To: Elle Donnelly
From: David Richards
Subject: J17300 - New England Solar Farm - Information request

This memorandum provides a consolidated response to DPIE's request for additional information (dated 5 December 2019). A set of updated project figures is provided in Appendix A.

Regional context

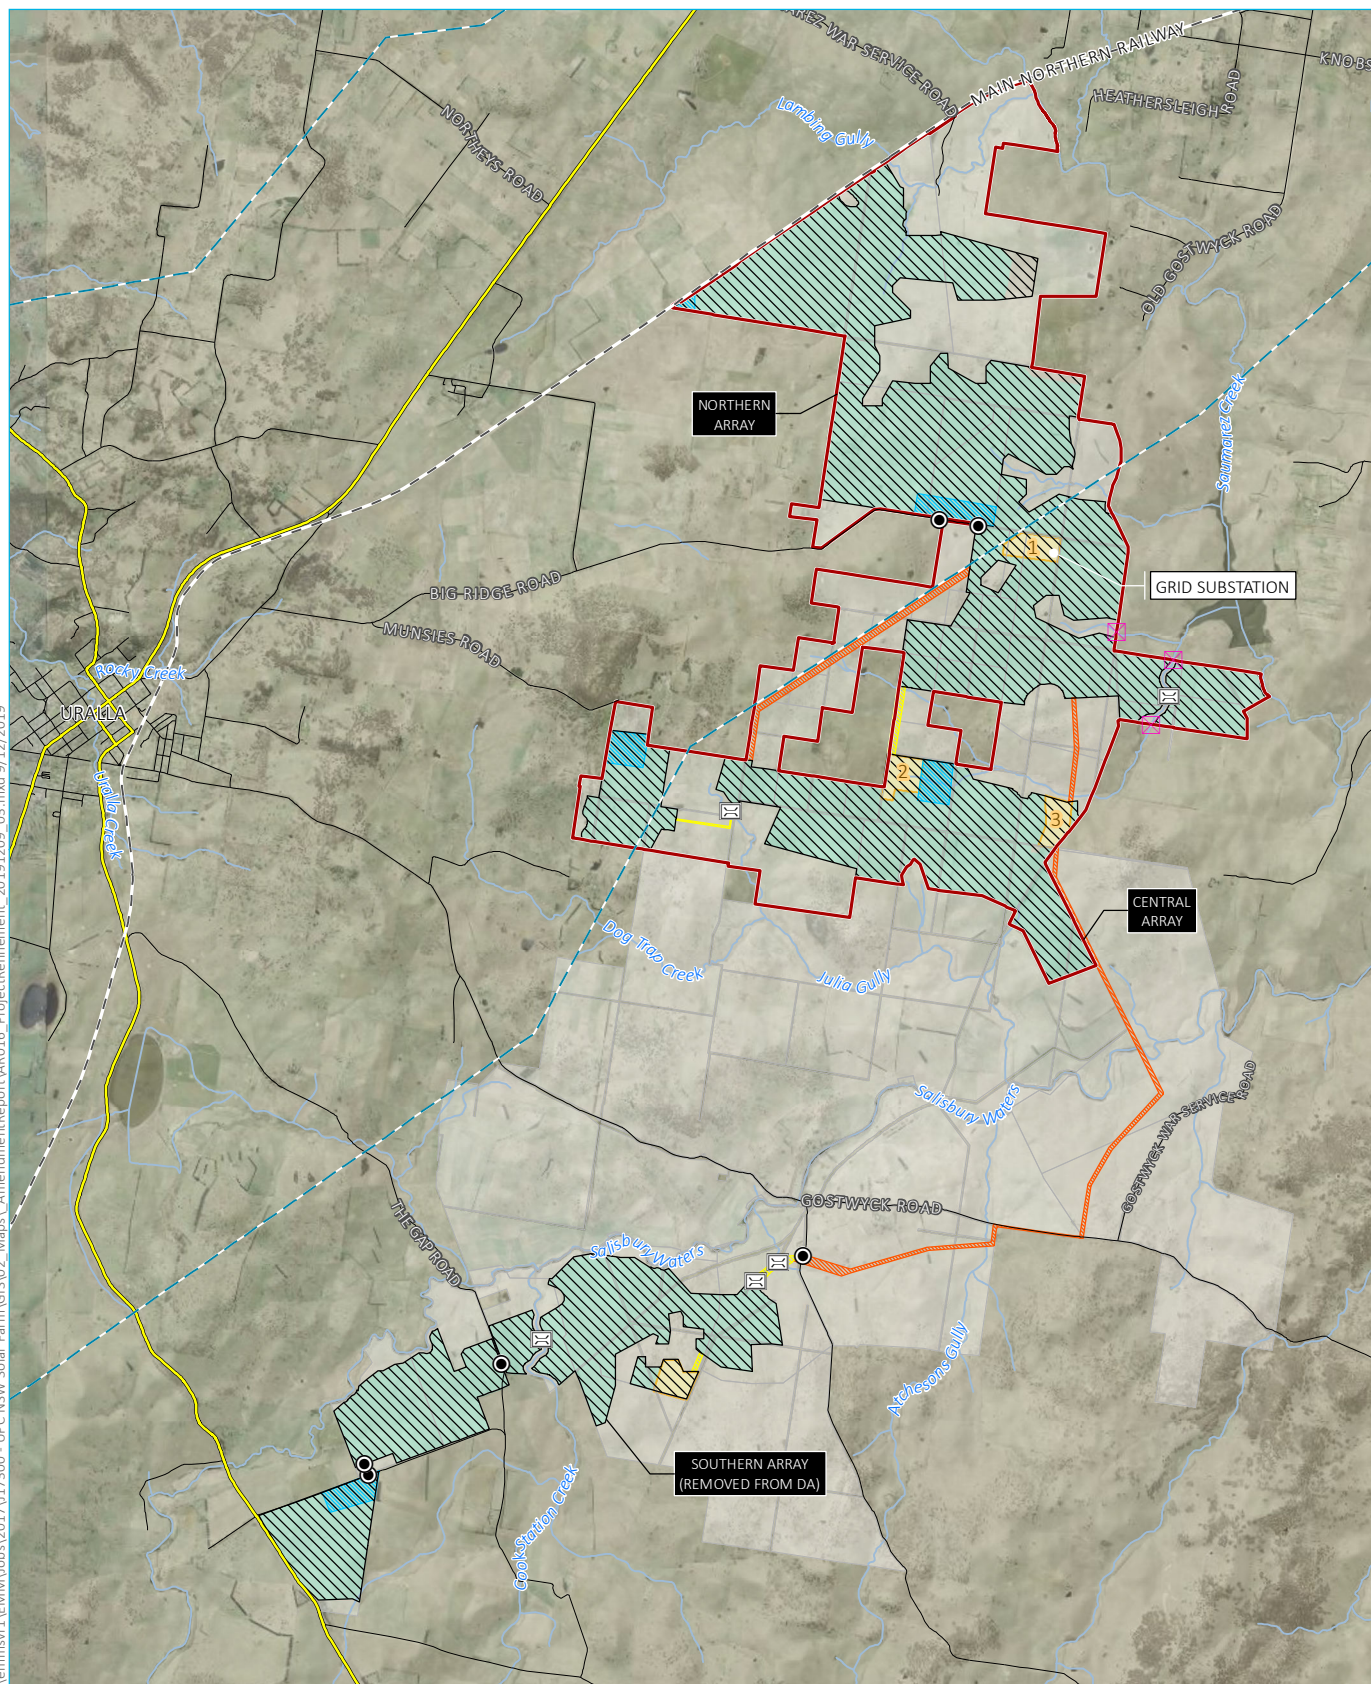
- Regional context – updated to include the indicative footprint of Salisbury Solar Farm (SSD-10347);
- Project refinement – updated to include additional detail about the southern array area (removed from the DA) and areas where security fencing will cross third order watercourses;

Project layout

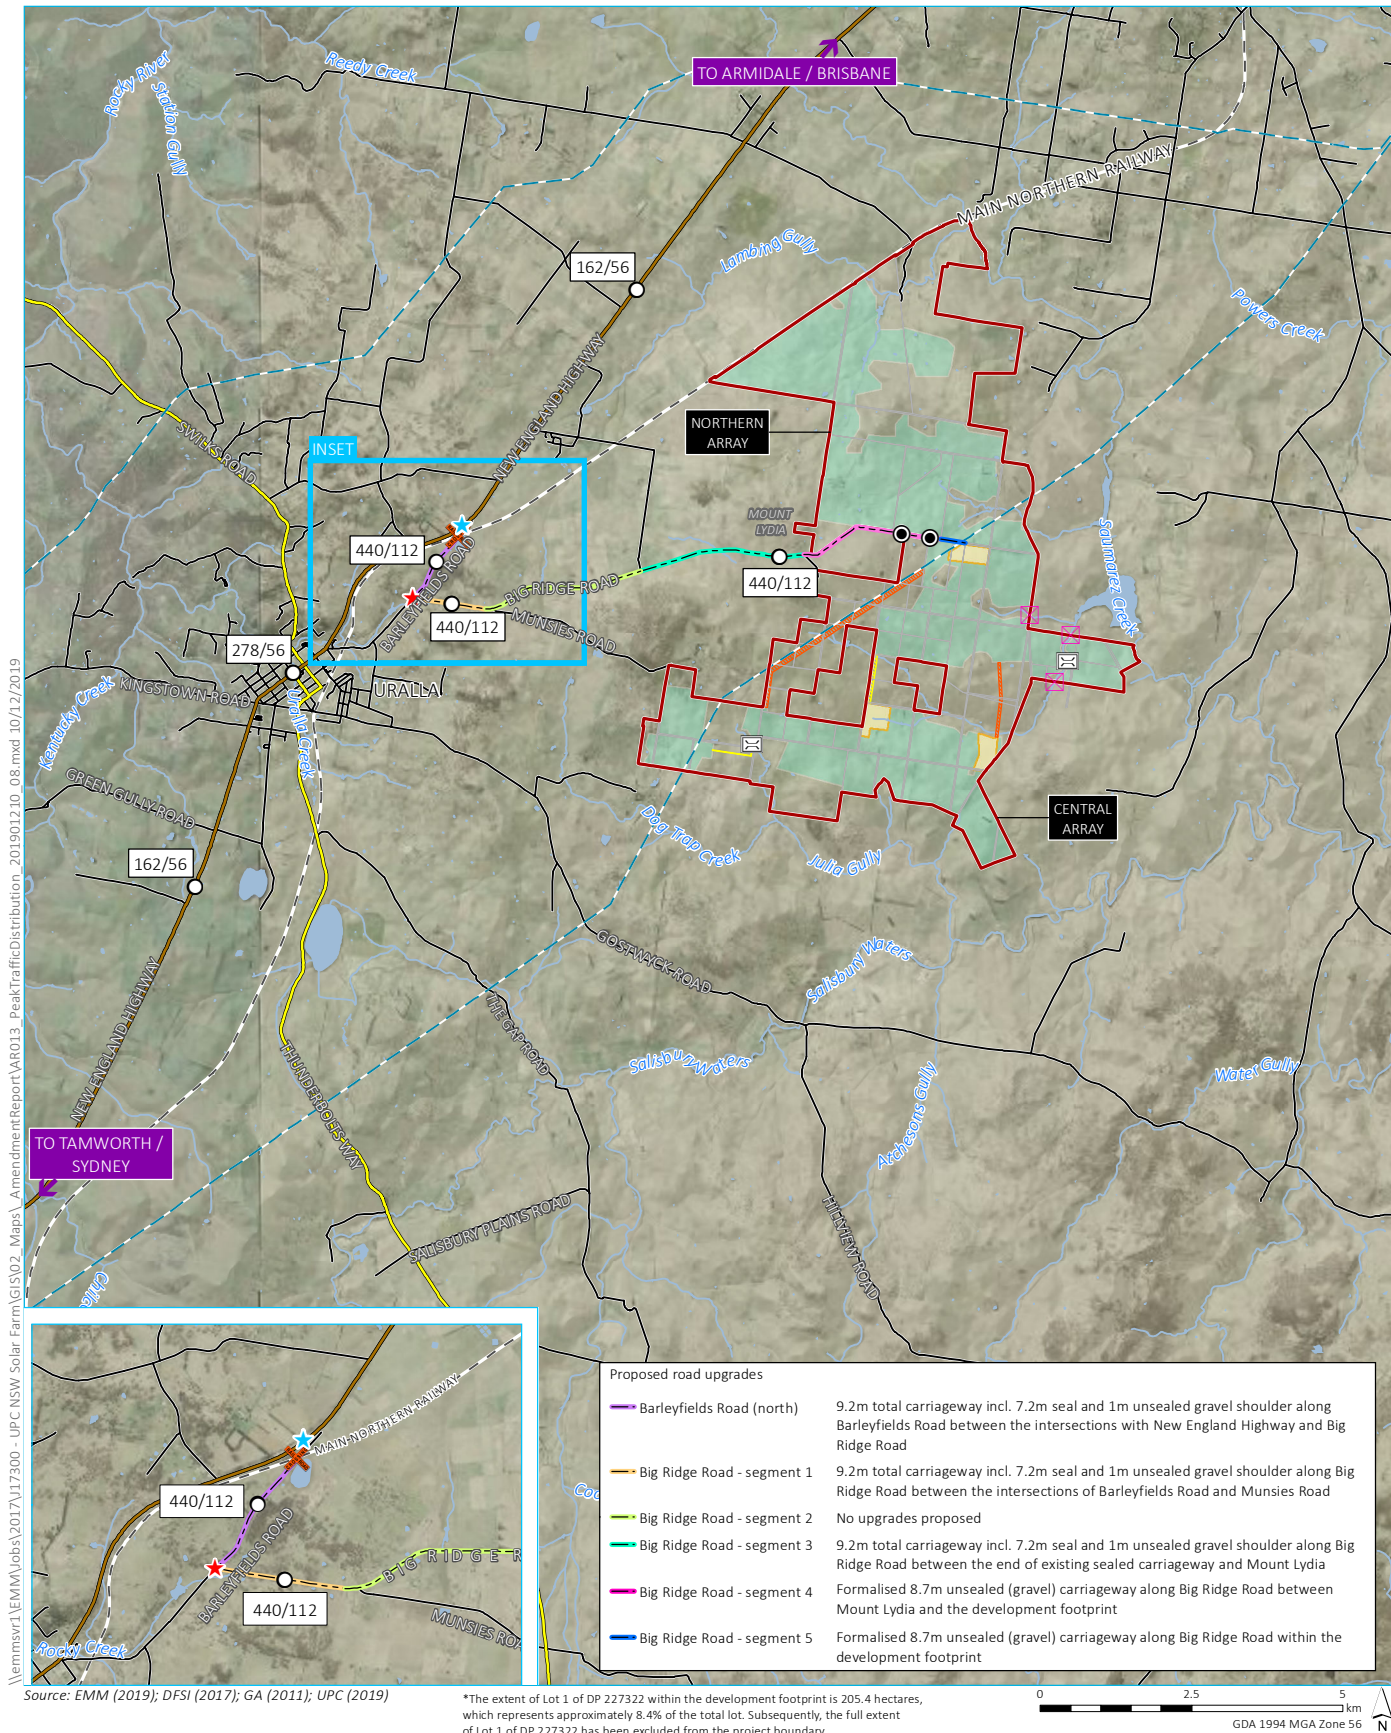
- Project layout – updated to include areas where security fencing will cross third order watercourses;
- Peak daily traffic distribution for Stage 1 and Stage 2 combined – updated to include areas where security fencing will cross third order watercourses and remove detailed information on upgrades to the intersection of New England Highway and Barleyfields Road (north);

Peak daily traffic distribution for Stage 1 and Stage 2 combined

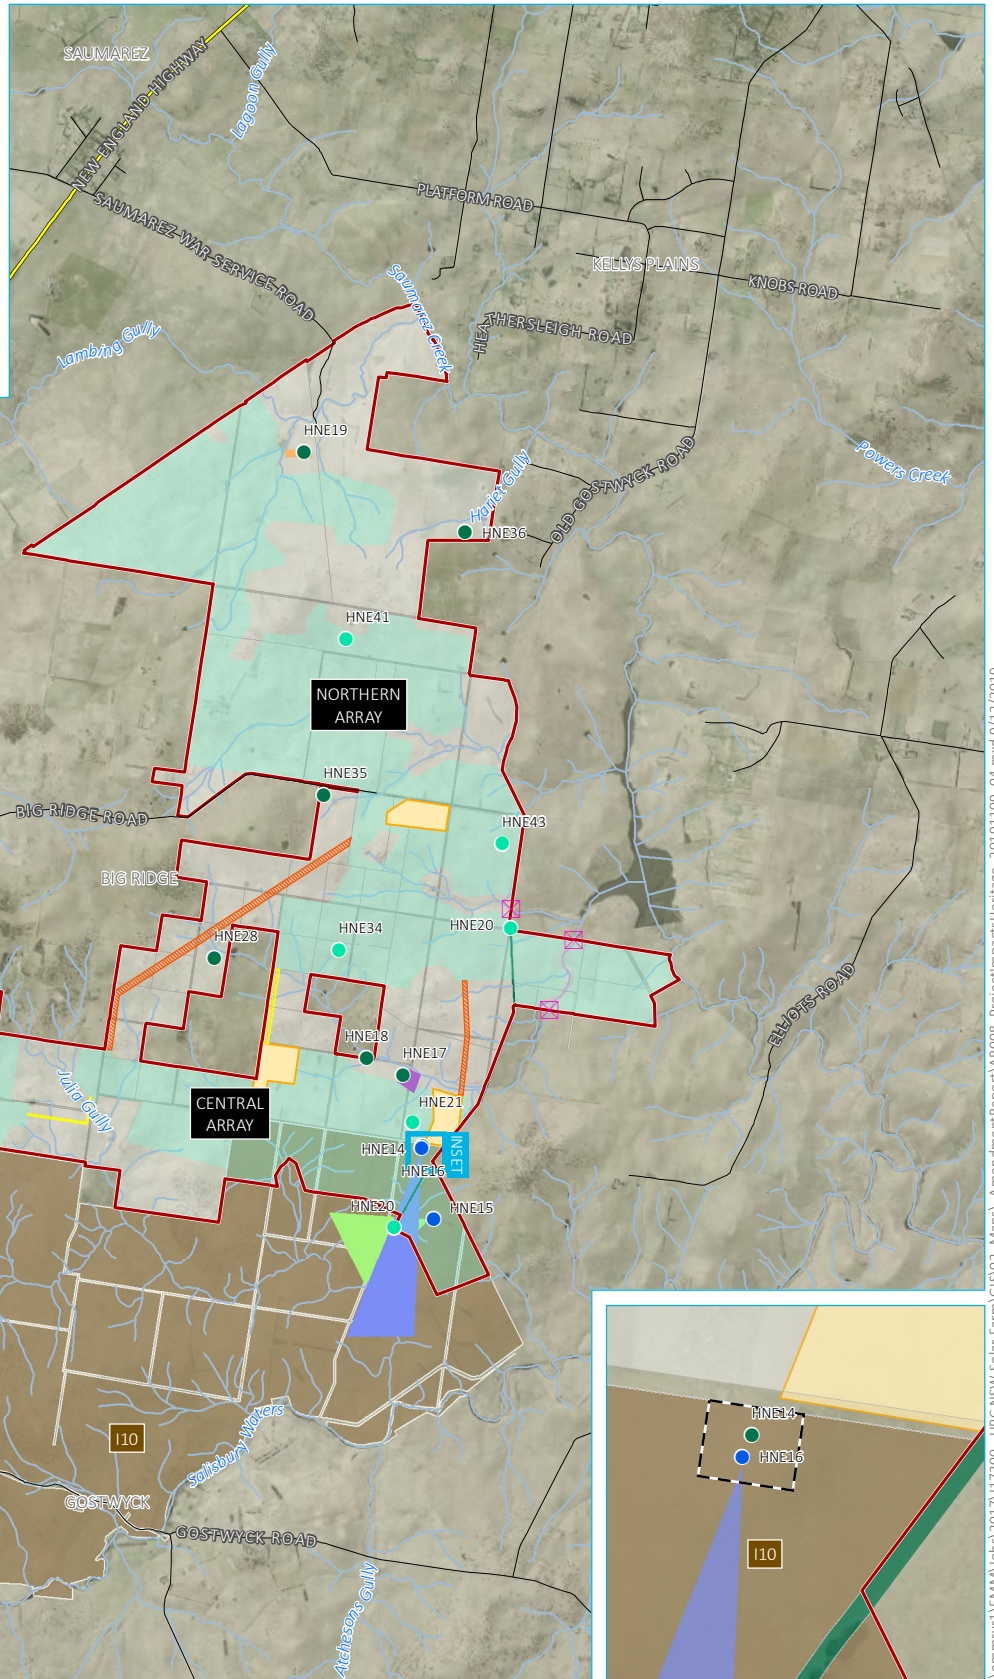
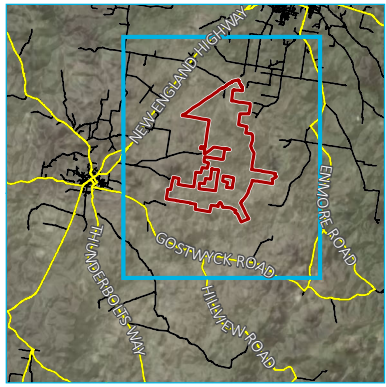
DPIE requested clarification of the proposed upgrade works for the intersection of New England Highway and Barleyfields Road (north).

As discussed earlier, the detailed information on the proposed intersection upgrade has been removed from the figure titled, 'Peak daily traffic distribution for Stage 1 and Stage 2 combined'.

It is understood that, consistent with RMS advice, DPIE has amended Appendix 4 of the proposed consent conditions to remove requirements for a basic left turn (BAL) at the intersection of New England Highway and Barleyfields Road (north).

It is understood that a requirement for a channelised right turn (CHR) treatment has been included in the proposed consent conditions. The CHR will cater for the largest vehicle accessing the site (excluding over-dimensional vehicles).

Project impacts to identified heritage values

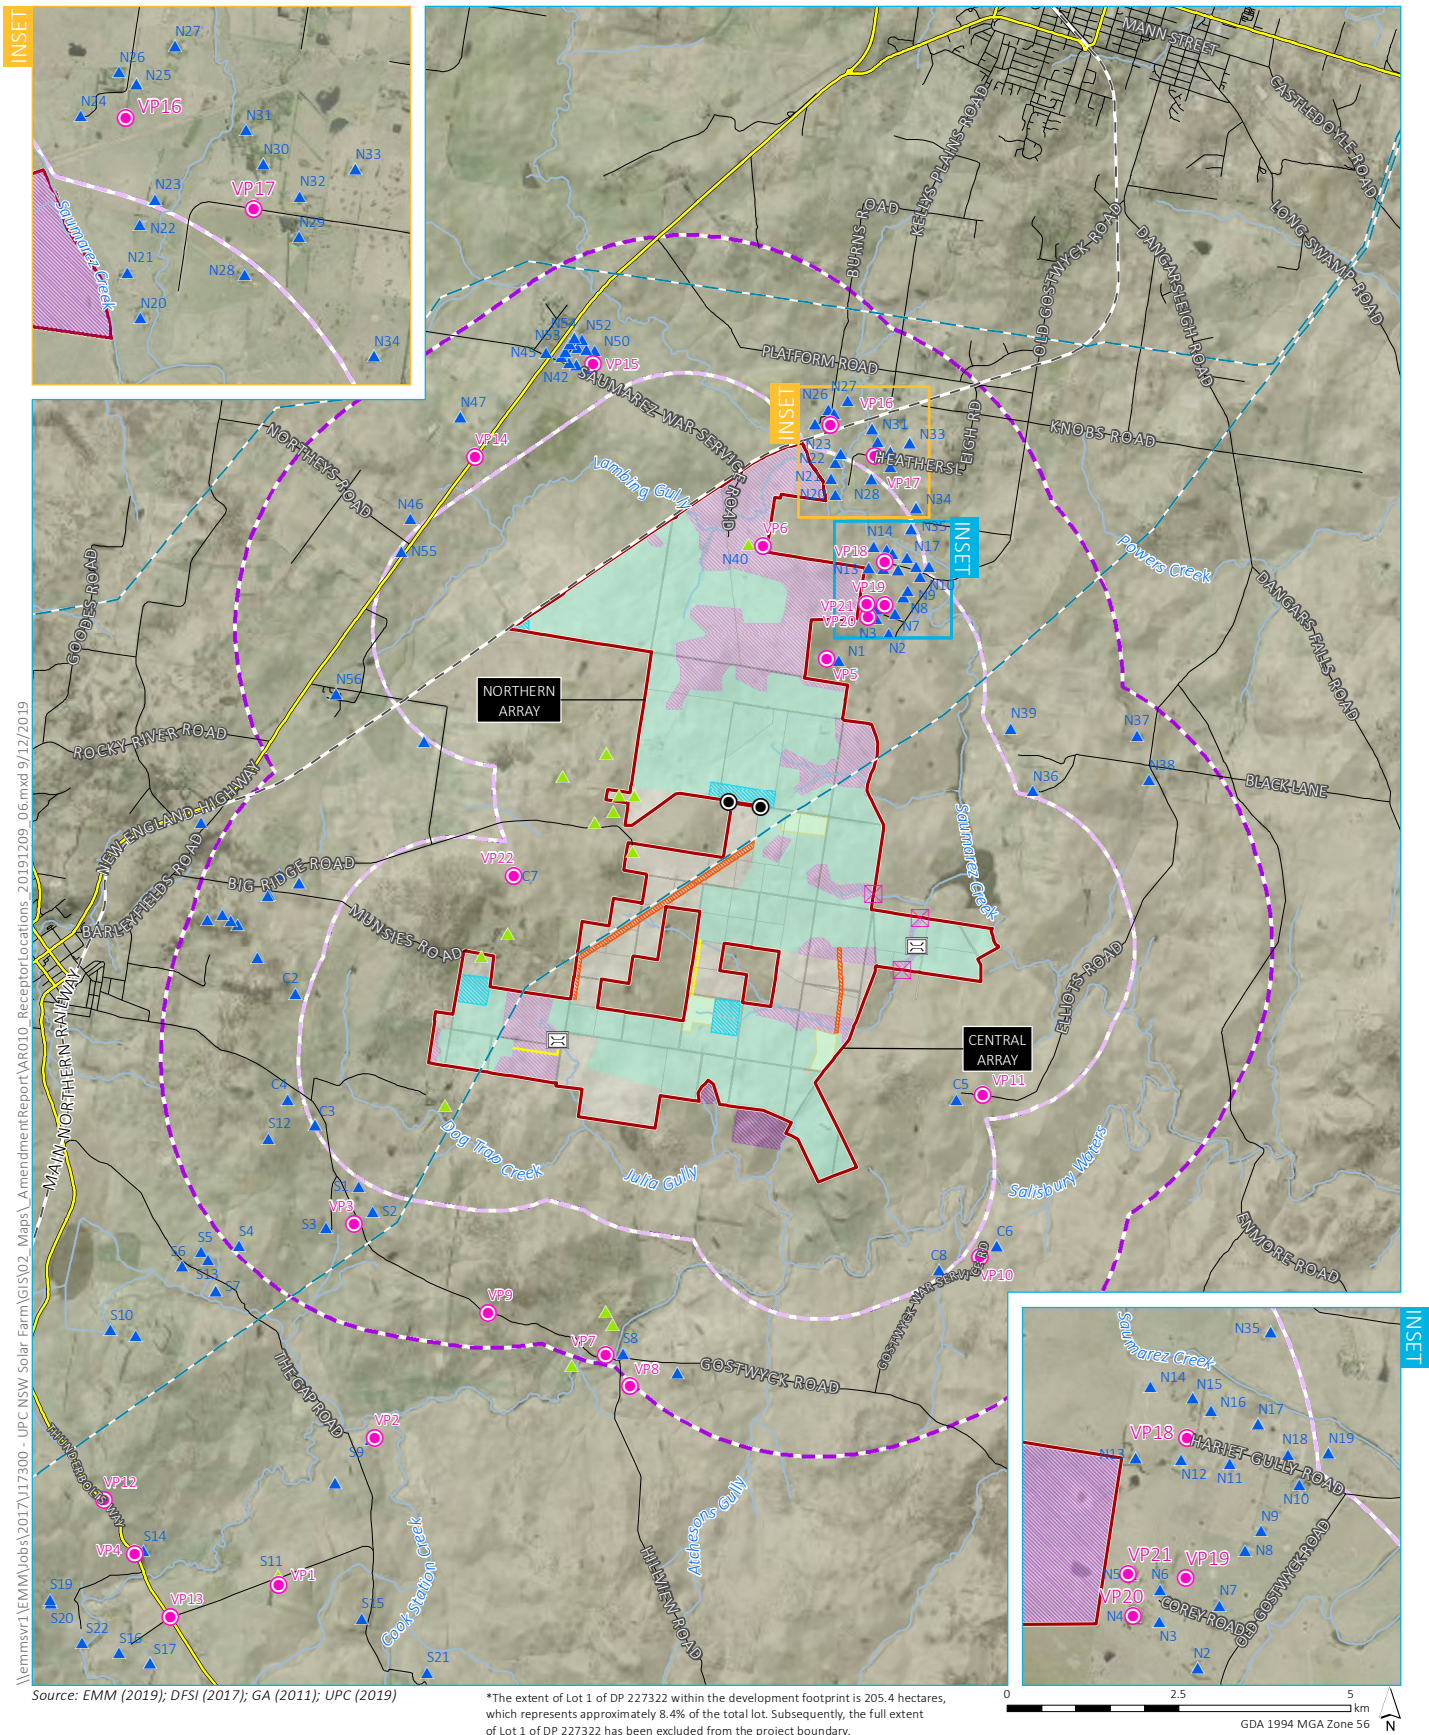
- Project impacts to identified heritage values – updated to include areas where security fencing will cross third order watercourses;
- Assessed viewpoints, sensitive receptors and project refinements – updated to include areas where security fencing will cross third order watercourses; and
